UNITED STATES
NUCLEAR REGULATORY COMMISSION
WASHINGTON, D. C. 20555

APPLICANT: Public Service Electric & Gas Company (PSE&G)
FACILITY: Hope Creek Generating Station
SUBJECT: SUMMARY OF STRUCTURAL AND GEOTECHNICAL ENGINEERING
BRANCH (SGEB) MEETING

On August 1, 1984, a meeting was held in the Bethesda, Maryland offices of the NRC to discuss the remaining SGEB-Structural audit open items identified in the Draft SER. A list of meeting attendees is included as Enclosure 1 to this meeting summary.

FIGURE A-13-29
RESPONSE SPECTRA COMPARISON,
AUXILIARY BUILDING AT ELEV. 54'-0".

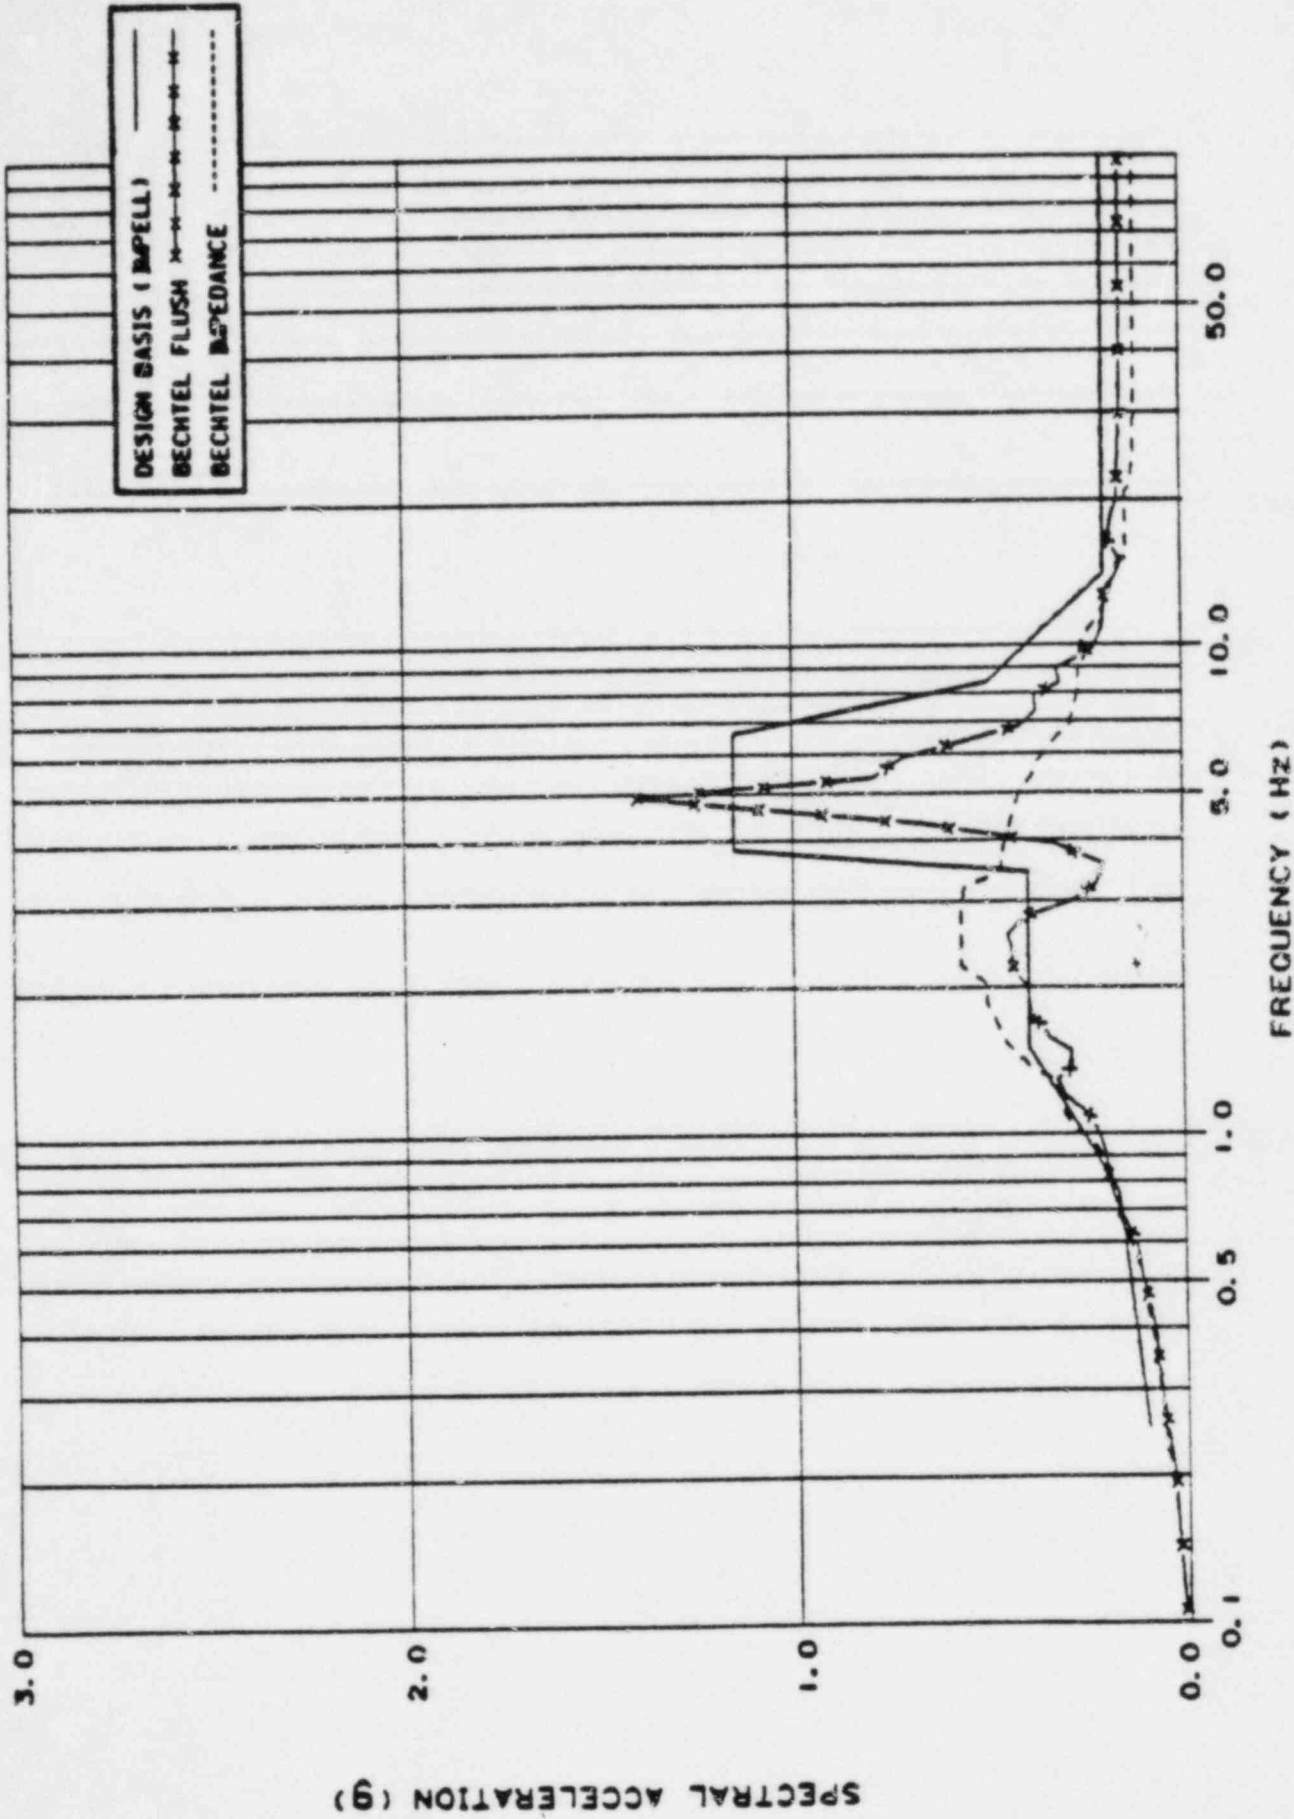
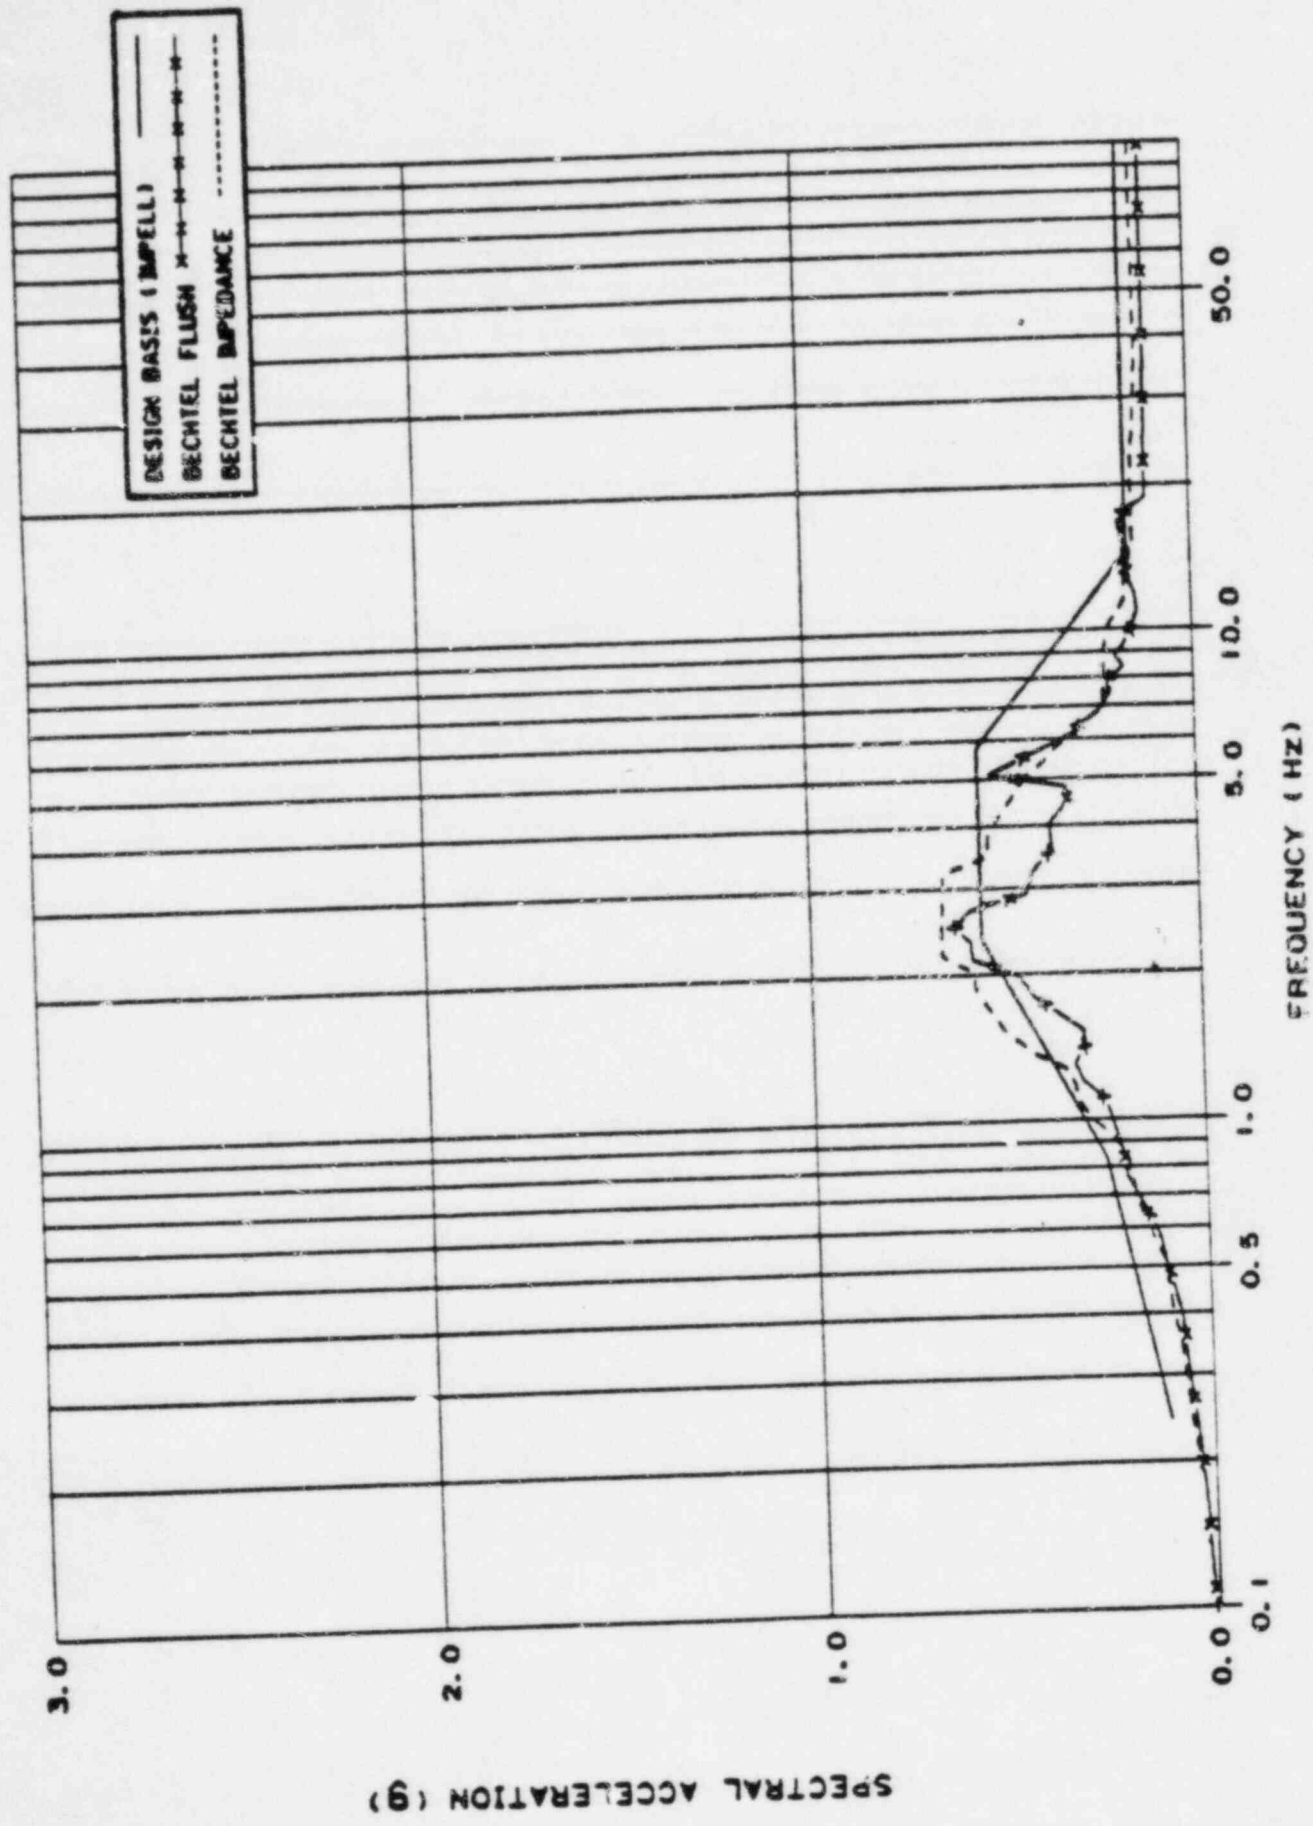
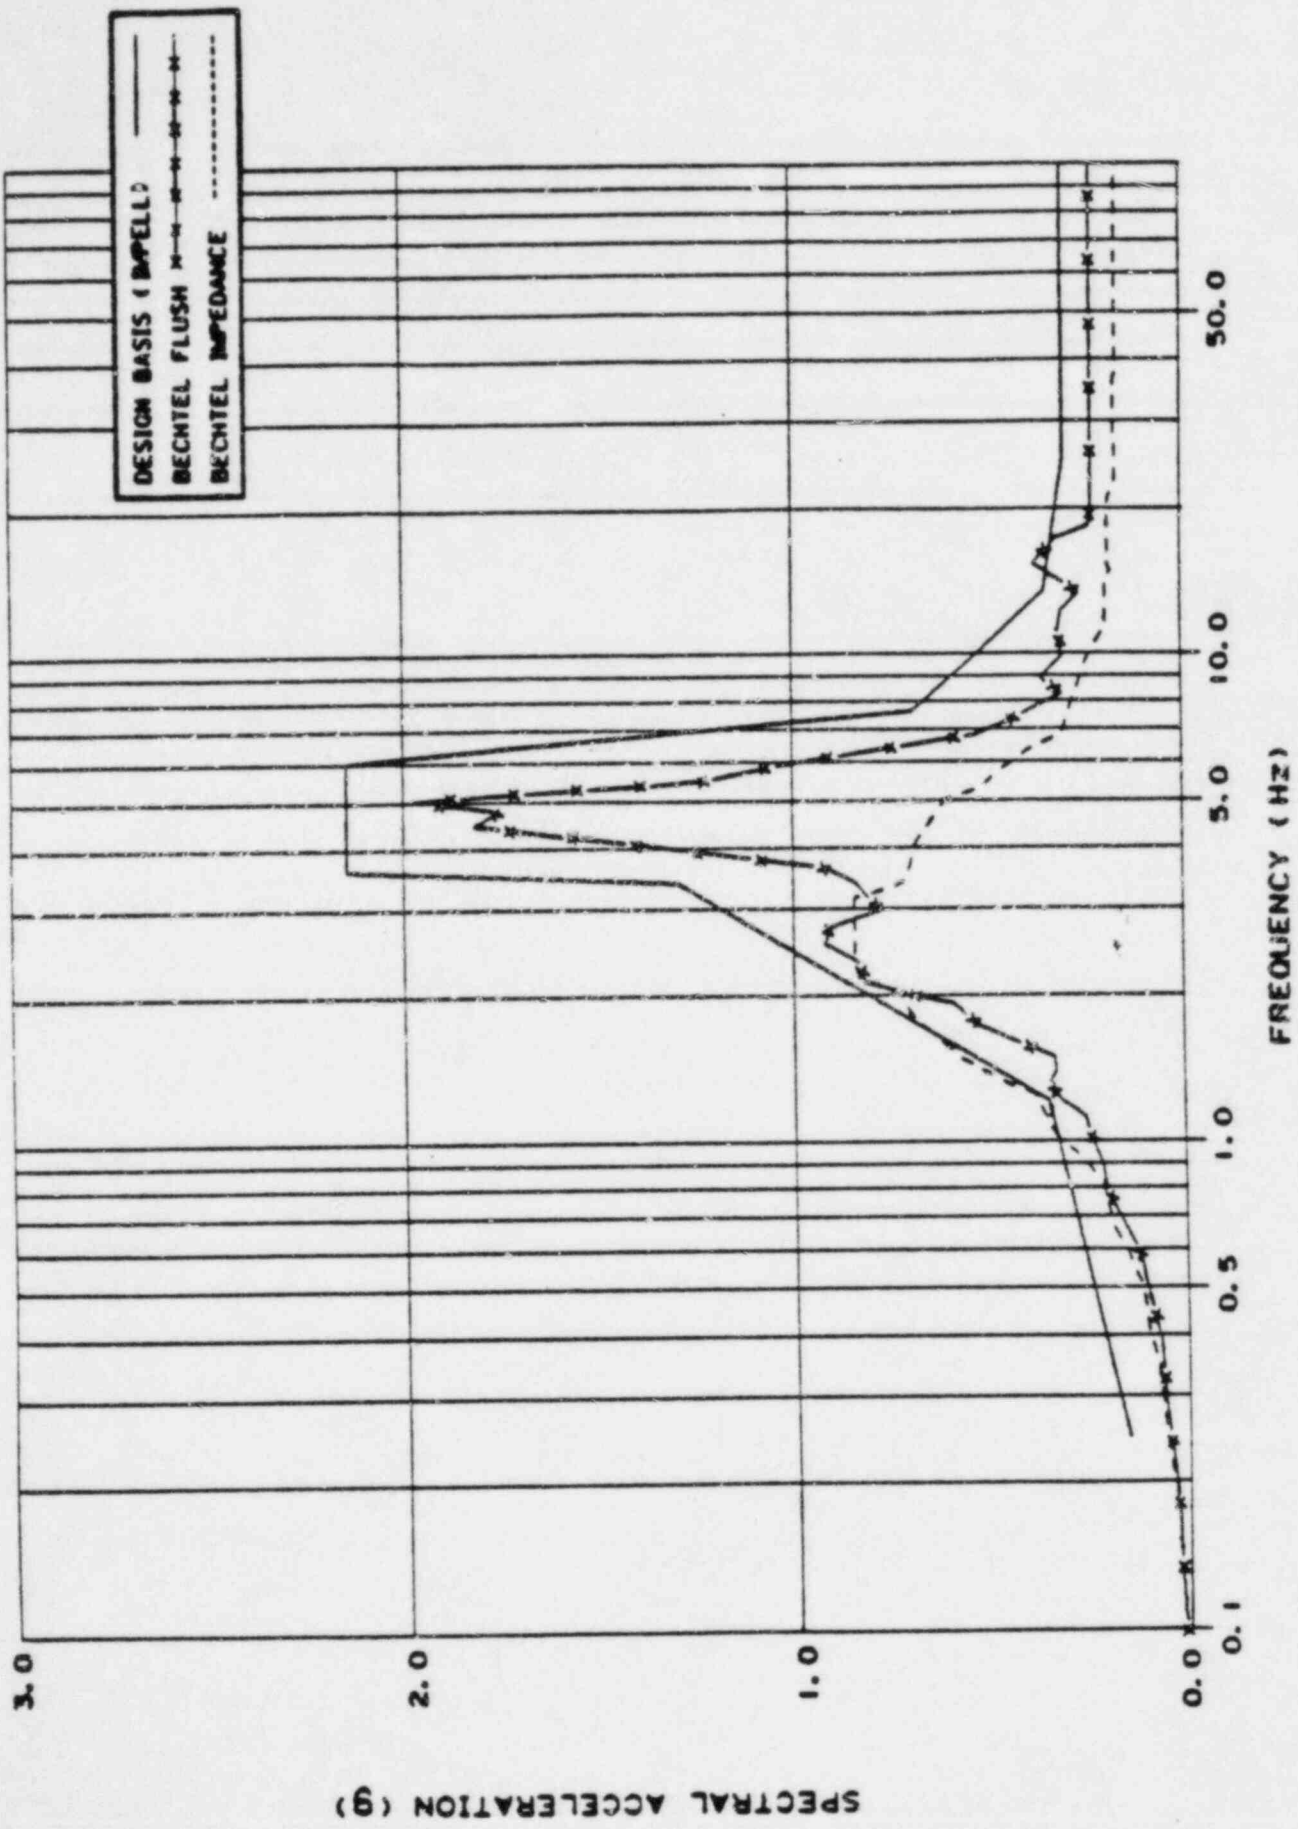
Question: Provide comparison of Bechtel Independent Verification Results with the Design Basis Results.

Figures A-13-2 to A-13-37 show the comparison of the response spectra (2% damping) obtained from the above three seismic soil-structure interaction analyses. Discussions of these comparisons are as follows:

Bechtel's independent soil-structure interaction analyses are performed using the computer code FLUSH. The results of independent finite element analyses are in reasonable agreement with those of the design basis analyses. As can be seen from Figures A-13-2 through A-13-37, the horizontal response spectra obtained from the independent finite element analyses are generally enveloped by those obtained from the design basis analyses except for the frequency range lower than 2 Hz. The vertical response spectra showed some exceedances at the frequency range of 18 Hz. These exceedances are listed in Table A-13-1.

The peak spectral accelerations obtained from the impedance approach analyses are generally lower than those obtained from the design basis analyses. However, these response spectra are not completely enveloped by those obtained from the design basis analysis, especially in the frequency range between 1.0 and 3.5 Hz. Also, there are some local exceedances in the higher frequency range, as shown in Figures A-13-2 through A-13-37.
